SERVICE BULLETIN

M1522: 2021 TOURING - POWER OUTLET - PINNED INCORRECTLY

Figure 1. Front Power Outlet [132B]

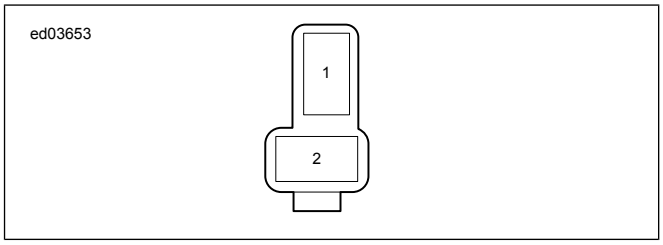
This bulletin is to notify Dealers that the inner fairing front power outlet [132B] on certain 2021 Touring, Touring Police and Trike Models may have been pinned incorrectly.

a. See Figure 1. Visually check to verify the correct wire location. Refer to Table 3.

3. **If wiring is incorrectly pinned:** Remove wiring and install into correct terminals. See the Electrical Diagnostic Manual (EDM).

TERMINAL	WIRE COLOR	CIRCUIT DESCRIPTION
1	V/BE	P&A relay power
2	BK	Ground
